DEVELOPMENT REVIEW COMMITTEE (DRC) COMMENT REPORT

PROJECT NAME: 317 N Federal

CASE NUMBER: UDP-S21003

REQUEST: Site Plan Level II Review: 716 Residential Units, 8,713 Square Feet of Commercial Use in Downtown Regional Activity Center

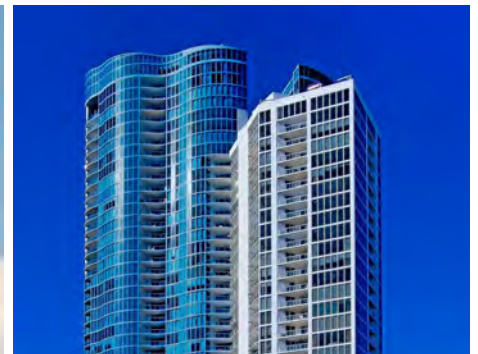
- 8) The proposed building is significantly larger in mass and scale than immediate surroundings. Mitigate building massing by incorporating stepbacks and transition the overall scale of the towers, paying particular attention to the transition across the residential areas across Federal Highway as well as the transition to the lower scale of projects in the Urban Neighborhood. The building towers should also contain a range of architectural styles with more vertical articulation in the building from ground level to the roof. Integrate more articulation by incorporating features such as large terraces, cut-outs open to the sky, and reconsider the large L-shape of the building. Refer to images below as design examples.
